Carderock Springs, Administrative Subdivision Plan No. 620200140

Completed: 5/28/2021

Administrative Subdivision Plan No. 620200140

Figure 3: Proposed Administrative Subdivision Lot Configuration.
Green shading represents existing (offsite) and proposed (onsite) conservation easements.

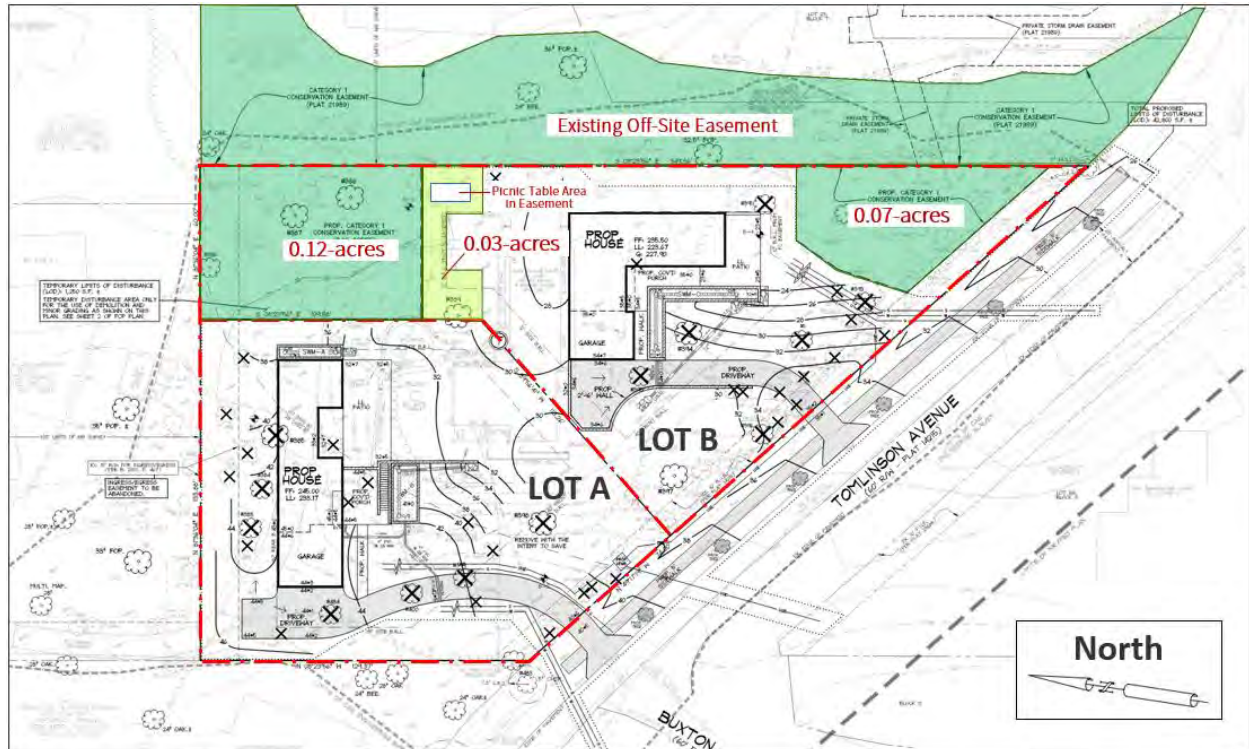
Although there is no forest on-site, this Application is subject to Chapter 22A Forest Conservation Law and has included a Preliminary/Final Forest Conservation Plan with this Application. The submitted worksheet calculates an Afforestation Requirement of 0.18-acres; and as conditioned, this requirement will be met onsite within two areas of new Category I Conservation easement. It is important to note that this property is located within the Palisades area of the 1990 *Bethesda-Chevy Chase* Master Plan, which contains distinctive environmental features, such as steep slopes and mature trees, that the Master Plan notes should be preserved and protected whenever possible; in an effort to maximize the protection of these environmental resources, the Applicant has proposed a total of approximately 0.22-acres of Category I Conservation Easement which considerably exceeds the calculated afforestation requirement for the proposed development. This 0.22-acre area consists of 0.19-acres of easement as proposed on the submitted Forest Conservation Plan as well as an additional of 0.03-acres of easement which was the result of further coordination between the Applicant and Staff during the plan review. This additional area will provide protection for a 41" specimen beech tree located near the existing residence. However, an approximate location for an outdoor table or play equipment is included of within a minor portion of the expanded easement area. As a result of this collaboration with the Applicant, Staff and recommends approval of the full 0.22-acres of easement as shown in Figure 3.

- b. Update Category I Forest Conservation Easement footprint to incorporate the additional easement area as shown in the Staff report.
 - c. Coordinate with Staff regarding minor clarifications, corrections, and updates which may be needed.

SHEET TITLE:
Fire Department
Access Plan

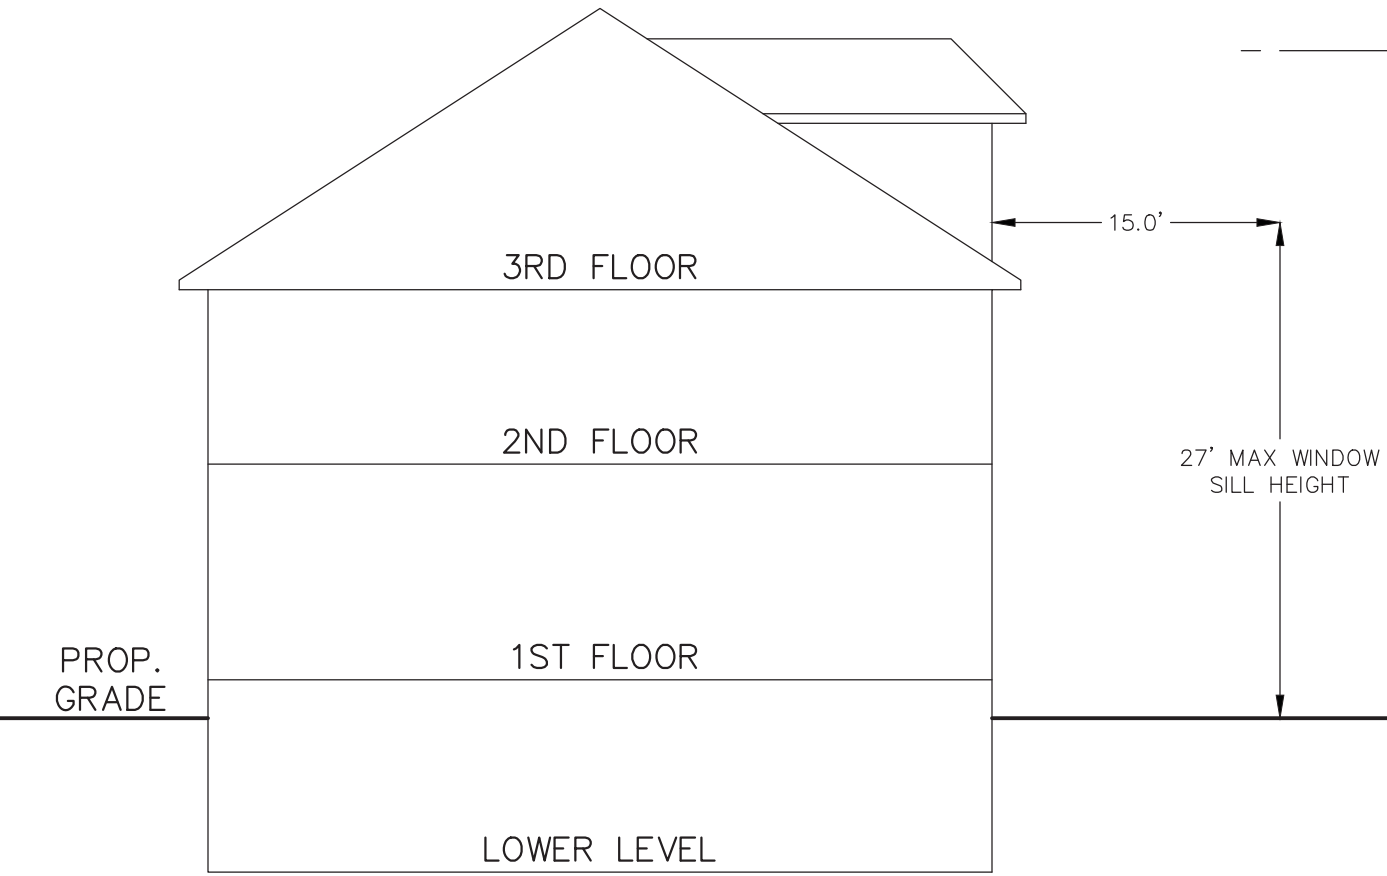
FIRE HYDRANT EAST OF
SITE: 328.2 FT TO
PROPOSED DRIVEWAY
ENTRANCE AS MEASURED
ALONG TRAVEL ROUTE

- ONE AND TWO-FAMILY DWELLINGS OF THREE (3) STORIES (27' TO HIGHEST SILL, INCLUDING FALSE DORMERS) OR LESS MUST PROVIDE ACCESS TO THE OCCUPIED INTERIOR THROUGH A MAIN, SIDE-HINGE DOOR WITHIN 150 FEET OF A FIRE DEPARTMENT ACCESS ROUTE.
- IF HOUSES ARE CONSTRUCTED MORE THAN 15' AWAY FROM ALL PROPERTY LINES THAN HEIGHT TO HIGHEST WINDOW SILL MAY EXCEED 27'.

PLAN APPROVED
